### **AMENDMENTS TO THE DRAWINGS**

The attached "Replacement Sheet" of drawings includes changes to Figure 6.  
The attached "Replacement Sheet," which includes Figure 6, replaces the original sheet including Figure 6.

Fig.6

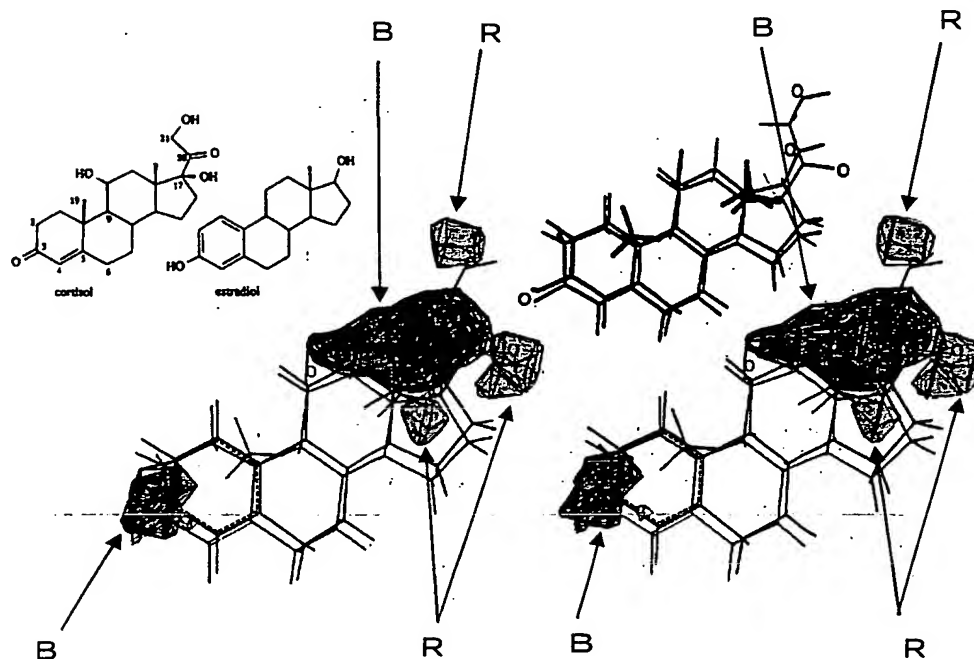
~~THICK LINES: REGIONS WHERE POSITIVE CHARGES WILL ENHANCE ACTIVITY~~

~~THIN LINES: REGIONS WHERE NEGATIVE CHARGES WILL ENHANCE ACTIVITY~~

B: REGIONS WHERE POSITIVE CHARGES WILL ENHANCE ACTIVITY

R: REGIONS WHERE NEGATIVE CHARGES WILL ENHANCE ACTIVITY
